**ADDENDUM NO. 2  
TO THE  
BIDDING REQUIREMENTS AND CONTRACT DOCUMENTS  
FOR THE  
DIV IV DRY WEATHER PUMP STATION AND FORCE MAIN REHABILITAITON**

**OWNER:** **City of Anderson**

**ISSUED BY/ENGINEER:** Egis Group  
8320 Craig Street  
Indianapolis, Indiana 46250

**ISSUE DATE:** December 24, 2025

PLAN DATE: 12/1/2025  
DESIGN: PRW CHECK: B&B DRAWN: DCW  
PROJECT NO.: 120046  
SHEET NO. C107

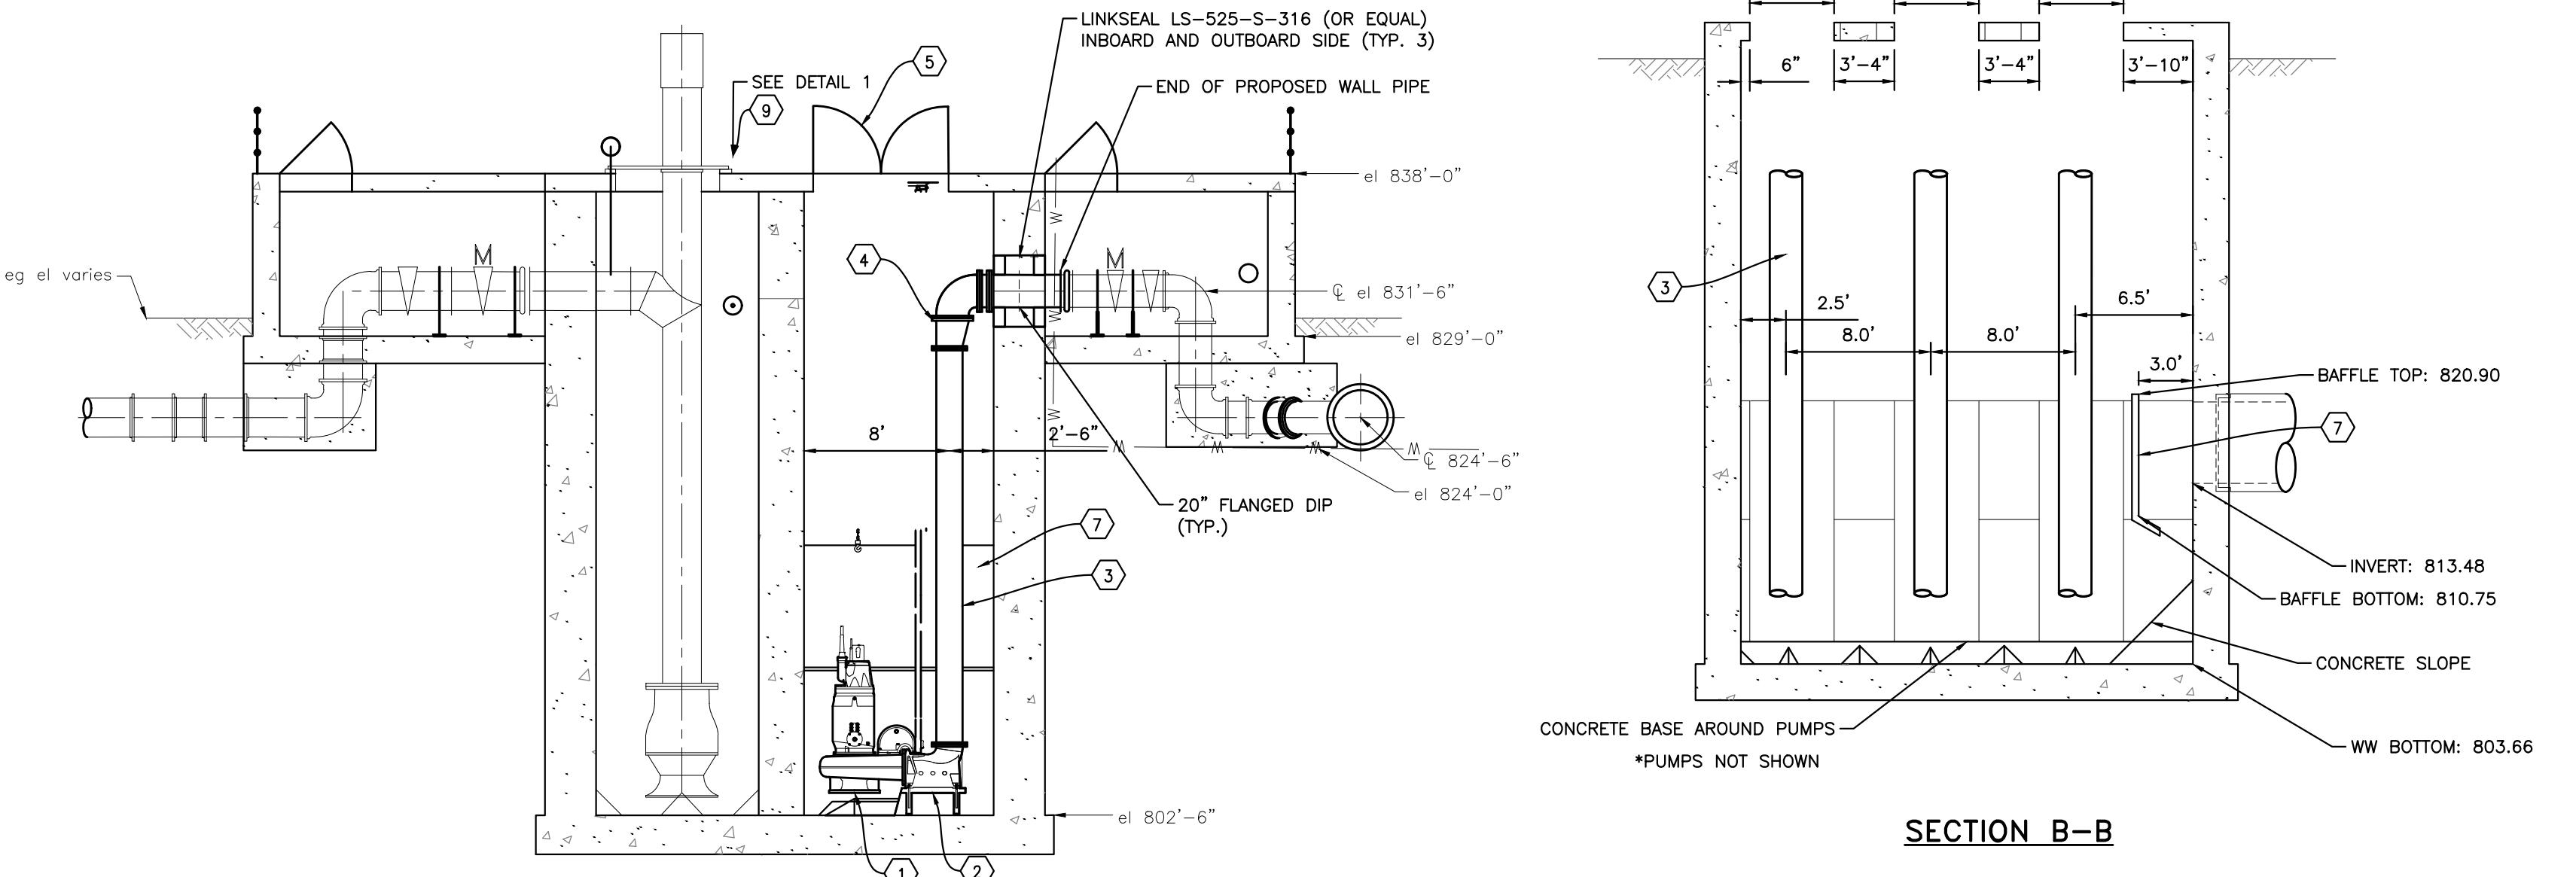
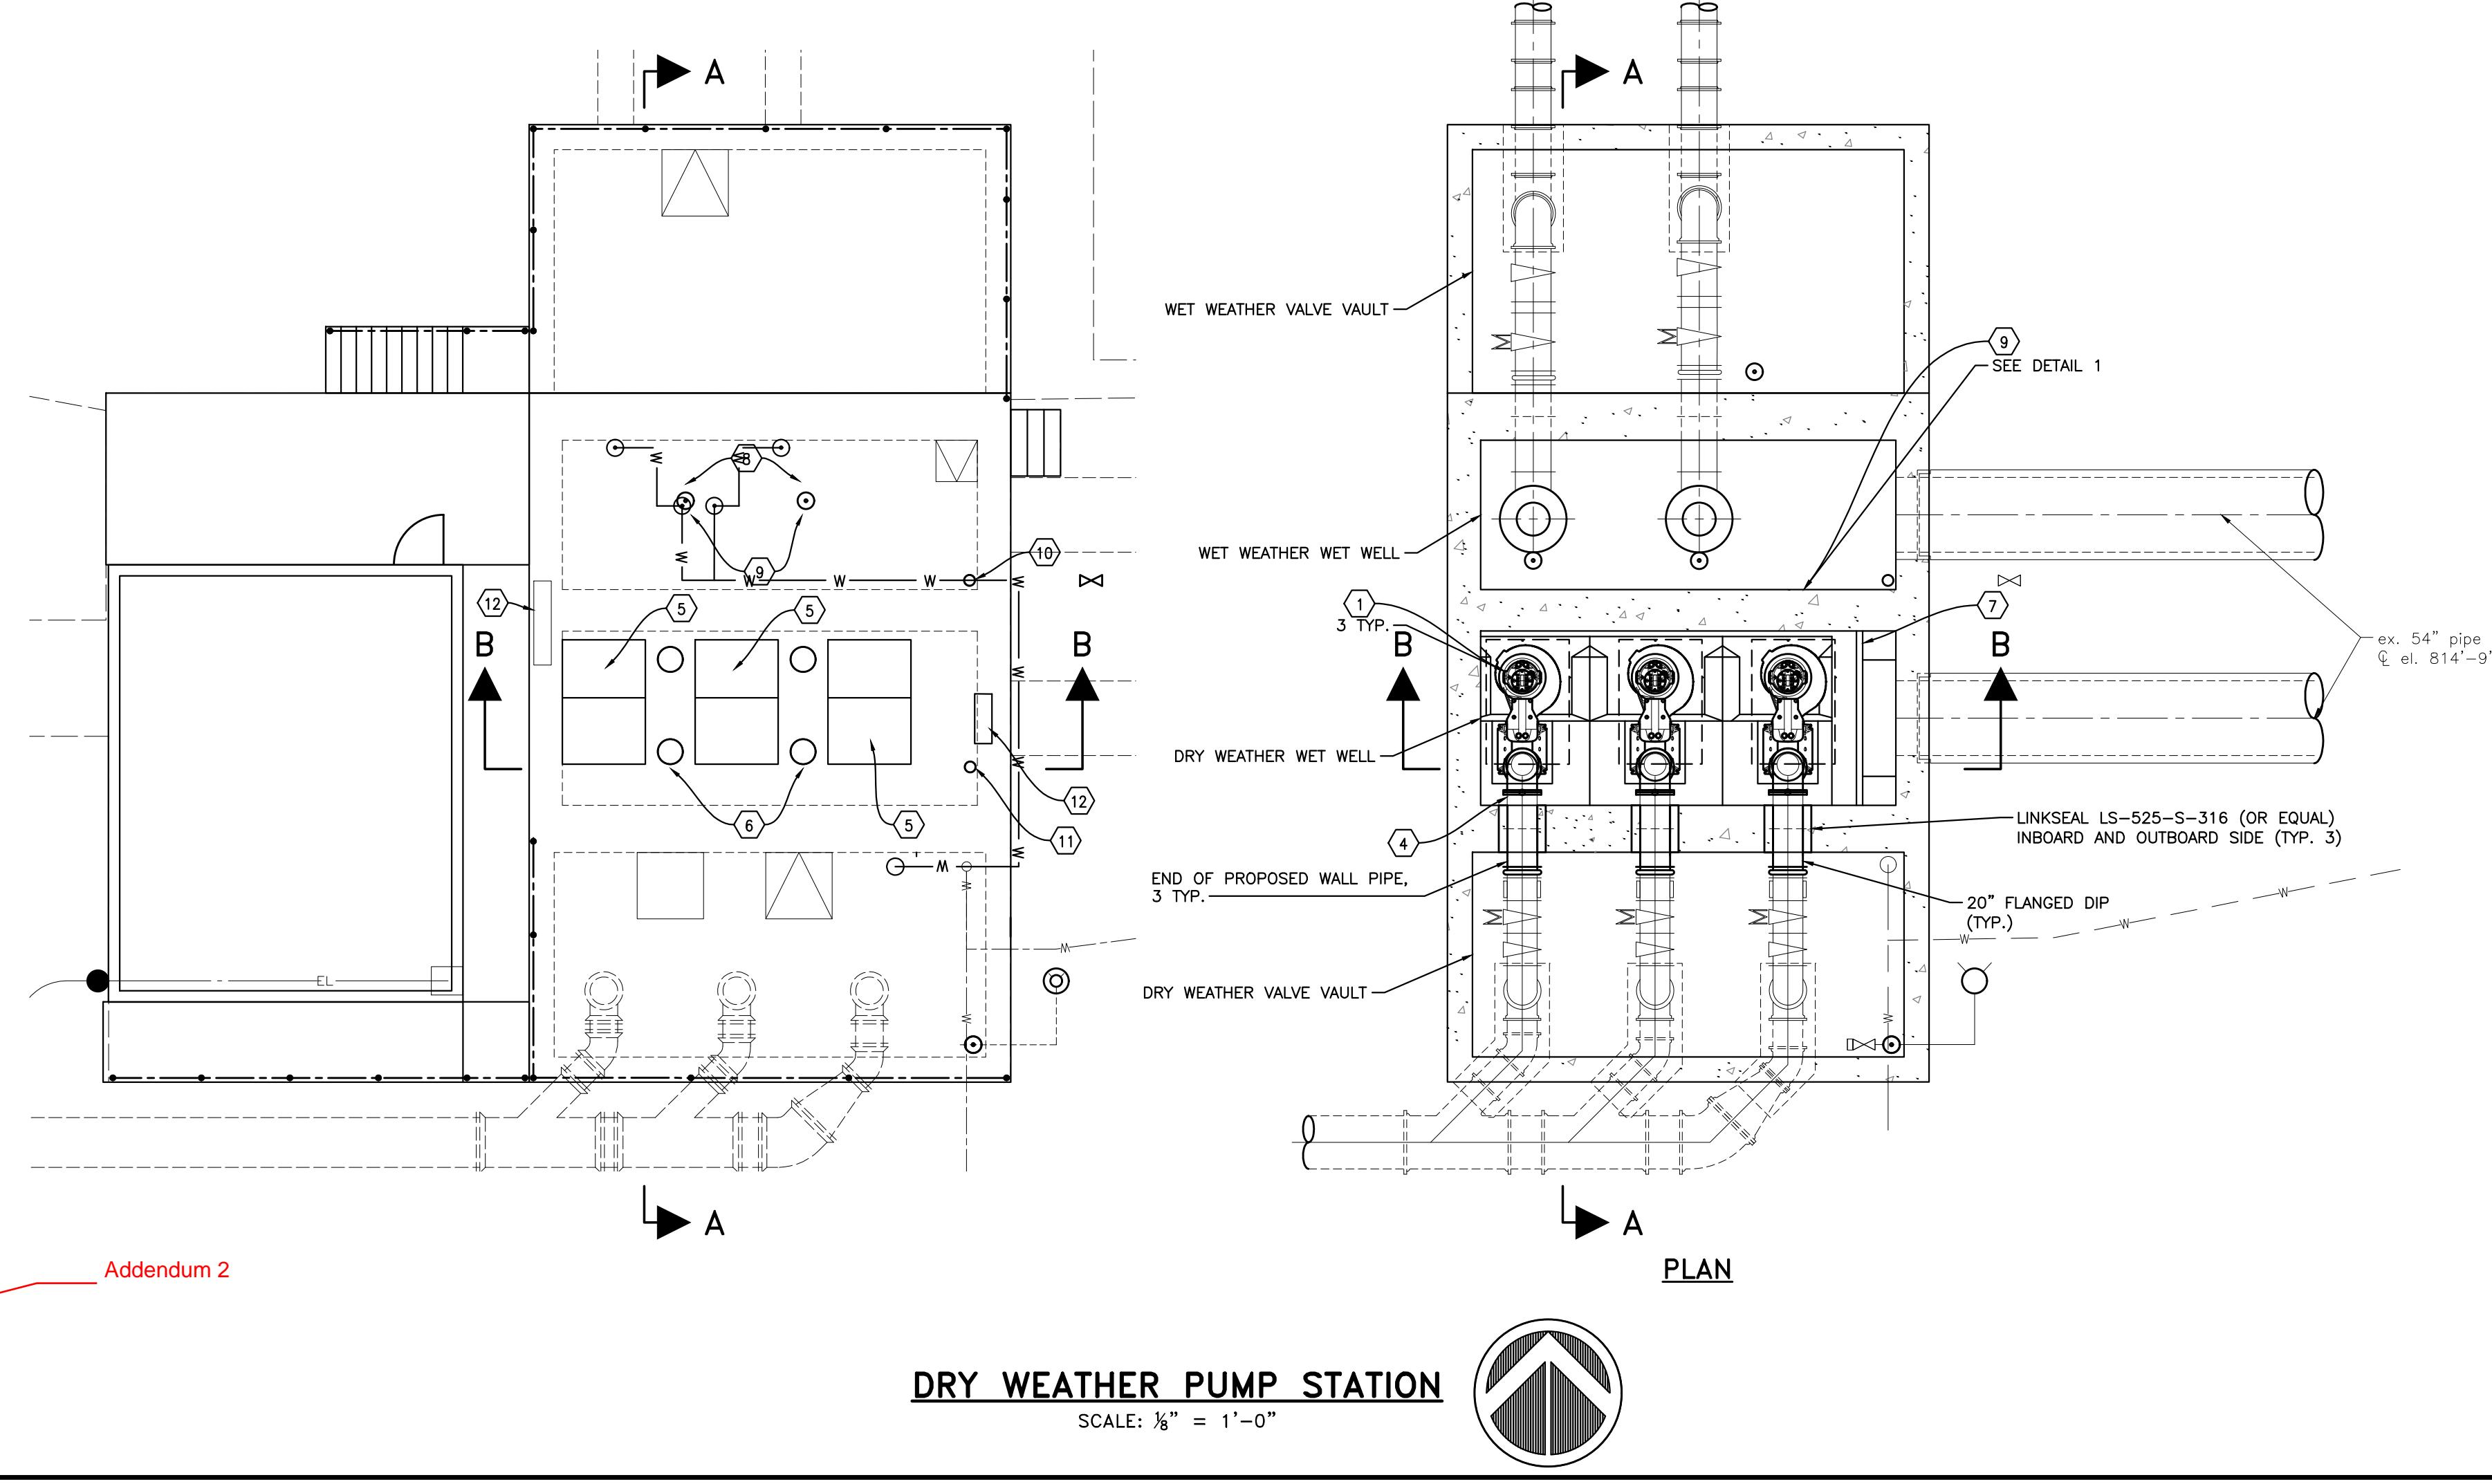
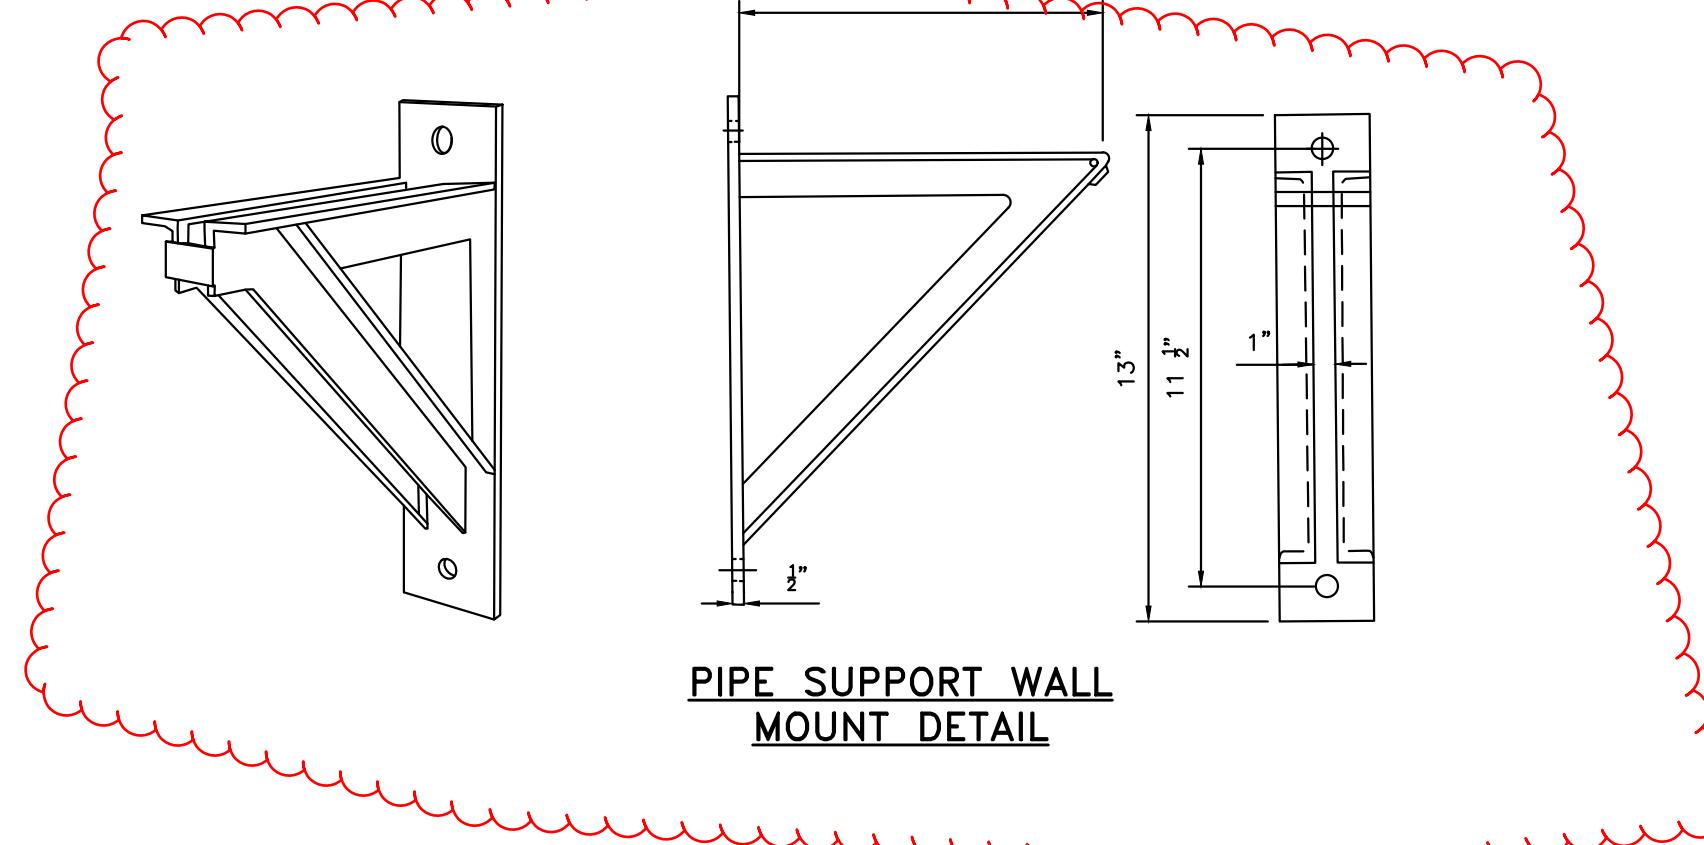
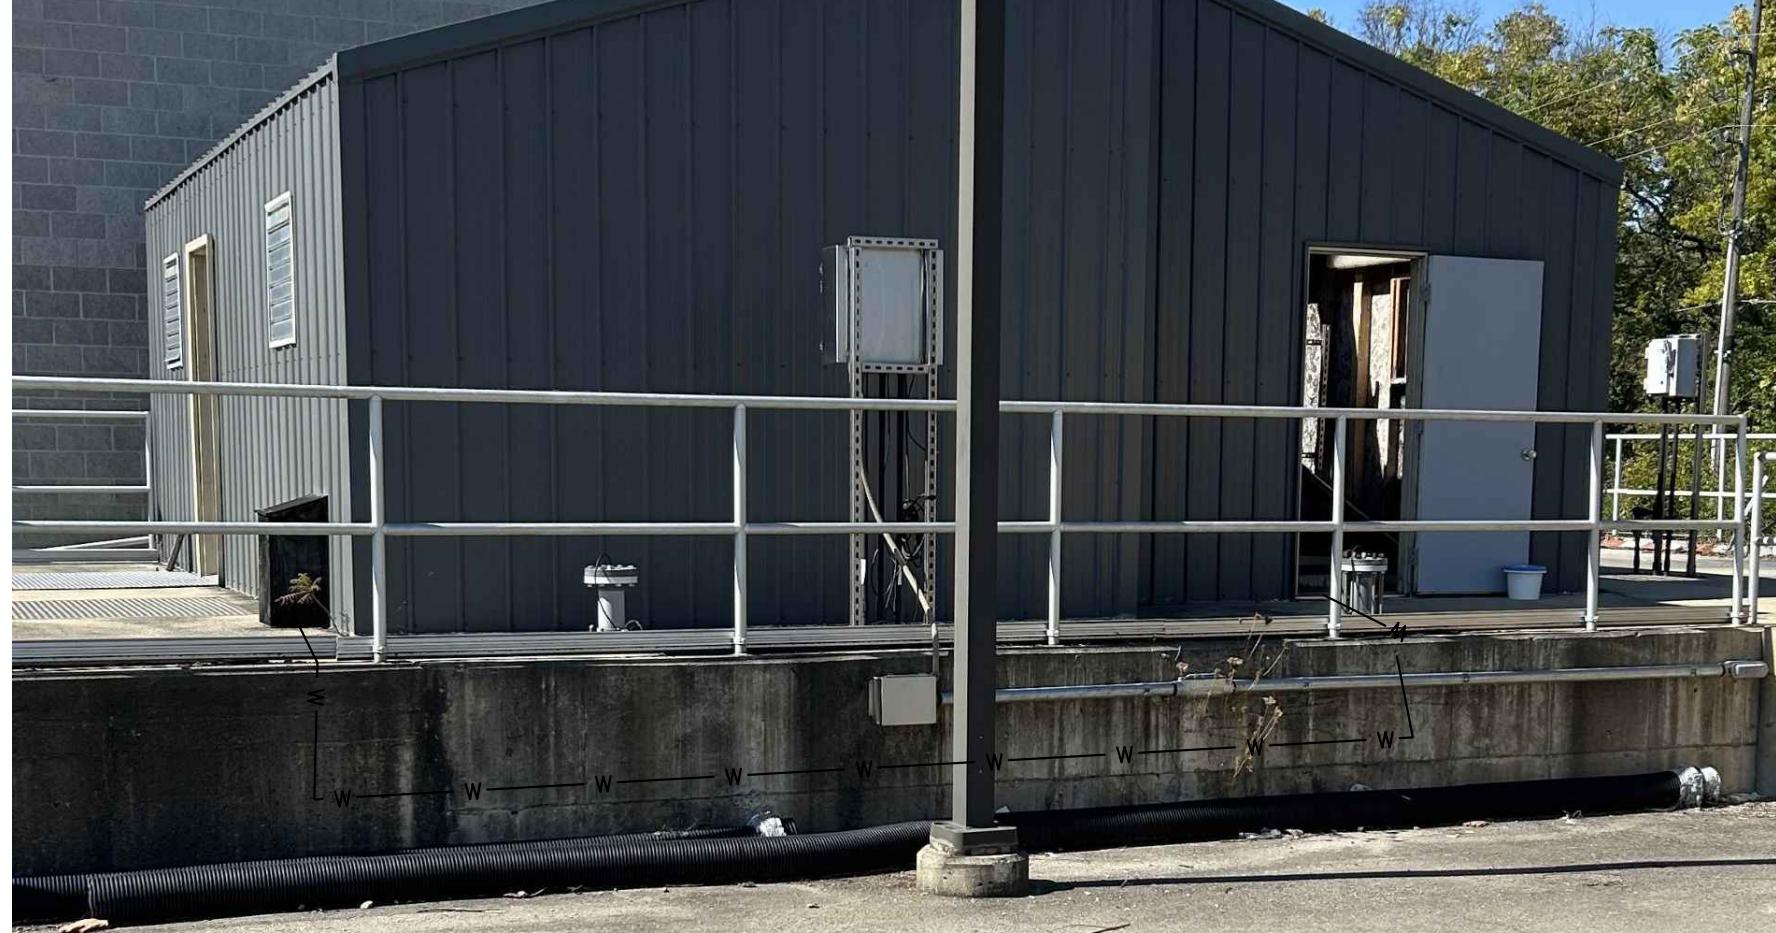
- A. Sheet C107 – Additional details have been added to Sheet C107.
- B. Sheet I106 – Additional information has been added to Sheet I106.
